Hi Noon Ski Club | 12 Banjo Drive, Thredbo | Proposed Concrete Access Ramp

Road Safety Assessment

P2094

Prepared for
Hi Noon Ski Club Ltd

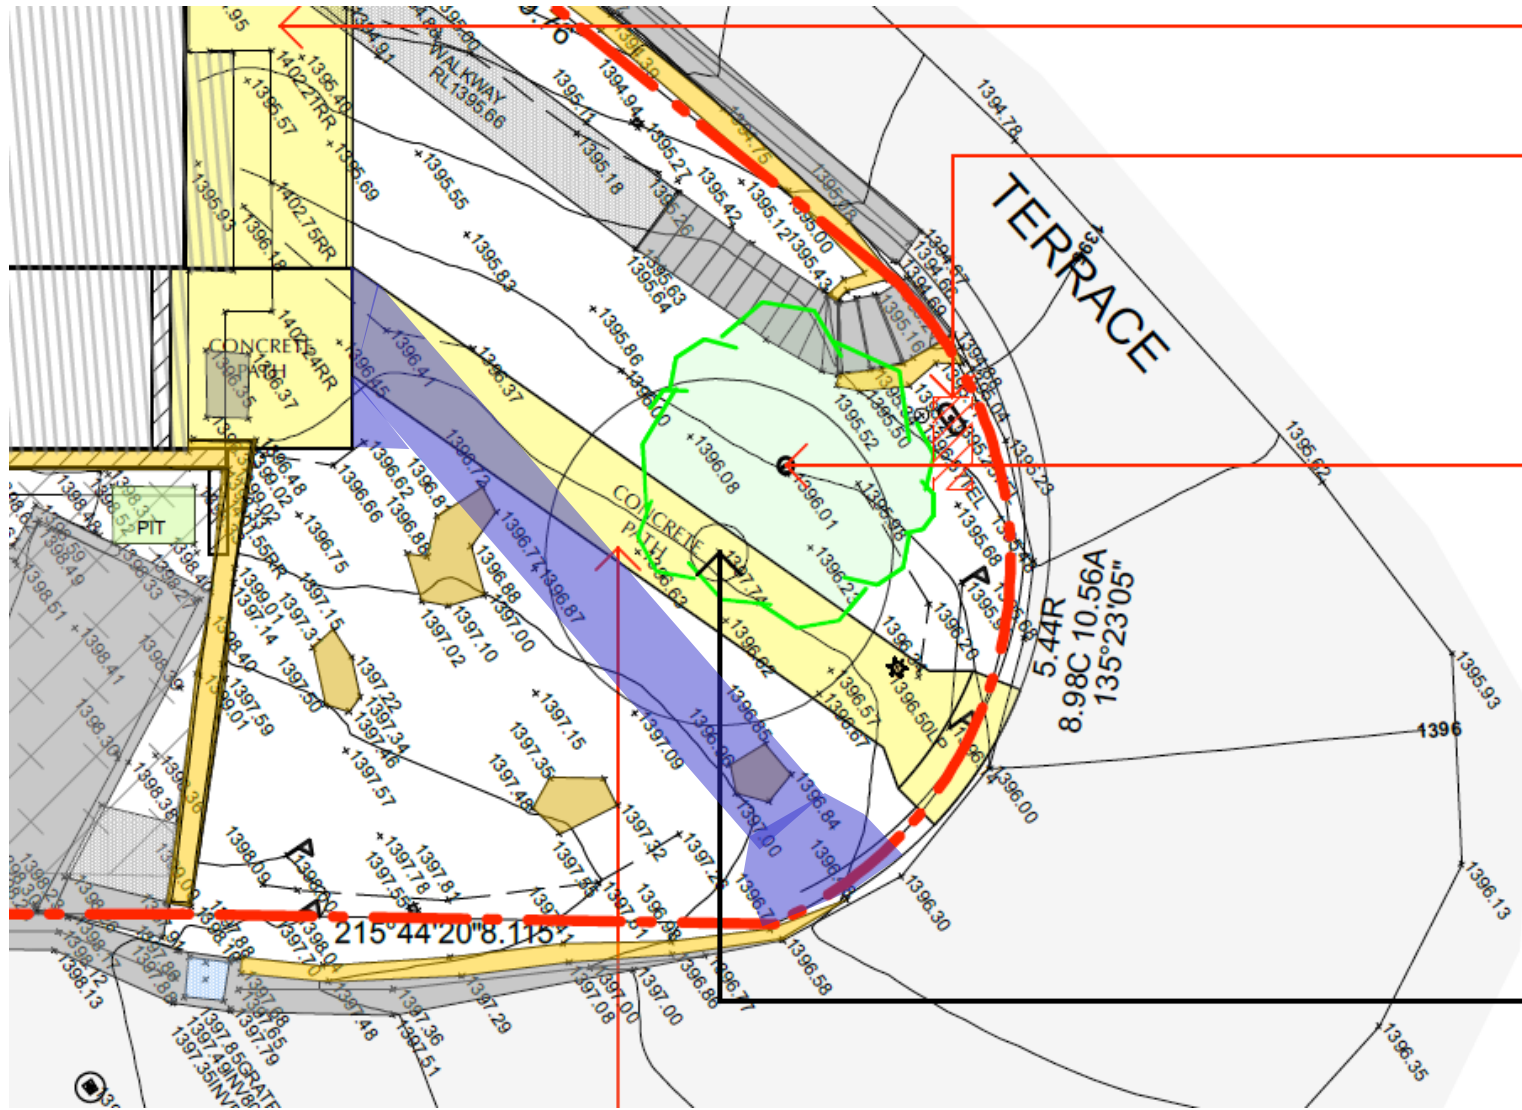
Please note that Practical Engineering Design Shows the tree outside of the footpath as it is the intension of the design and site measurements to protect the tree while building a pedestrian access footpath at Hi Noon Thredbo

The club has provided a sketch attached – where it indicates that the location of the tree is to remain.

This is to assess that there are no changes to the engineering design drawings listed above – regarding maximum slopes, etc - for wheel chair access footpath, while the tree is being retained.

LOCATION OF EXISTING LIGHT POST & STREET SIGN TO REMAIN.

LOCATION OF EXISTING TREE TO REMAIN

NOTE: TREE SHOWN IN PATH LINE DOES NOT EXIST.
